DEV NUMBER:  
DEV25-0026

REASON FOR DEVIATION:  
Allow for the models to run at a different installation torque that what's stated in specification in their respective drawing's current specification is 21 ft-lbs +/- 4 ft-lbs.  
Proposed deviated specification intallation torque of 14 +/- 2 ft-lbs and break away of 8ft-lbs Minimum. This is due to the driving equipment was updated to an electrical driver and the higher limit of that equipment is capped at 16 ft-lbs. This course of action was selected as a new model of regulator that will replace the current models is set to be released in the following months and this model will no longer be produced.

DRAWING NUMBER:115658  
DRAWING REVISION:B  
DEVIATION REVISION:B1  
DRAWING TITLE/ PART DESCRIPTION:PSI-M15,PRESS REG 2-22GPM  
VENDOR:Arimex

DEVIATION FORM (DRAWING)

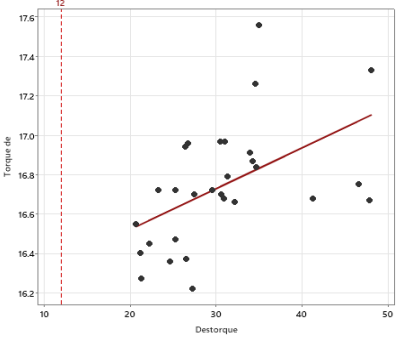
RISK ASSESSMENT/ CORRECTIVE ACTION PLAN (NAMES & DATES)/ COMMITMENT:  
Low: Testing has showed that material build to this specification had a lower break but didnt show any adverse effects to the function of the part. Scatterplot below show that current relationship bettween torque and breakaway specification is maintained assuring correct assembly also showed analisys of breakaway at the proposed instalation torque. PCO where builds are documented is 29751 & 29697.

IS: 2. ITEM 4 TO HAVE AN INSTALLATION TORQUE OF 14 FT-LBS  
+/- 2 FT-LBS REVERSE TORQUE SHOULD BE 8 FT-LBS MIN  
AND MONITORED NO LATER THAN 12 HOURS AFTER ASSEMBLY.

WAS: 2. ITEM 4 TO HAVE AN INSTALLATION TORQUE OF 21 FT-LBS  
±4 FT-LBS. REVERSE TORQUE SHOULD BE 12 FT-LBS MIN  
AND MONITORED NO LATER THAN 12 HOURS AFTER ASSEMBLY.
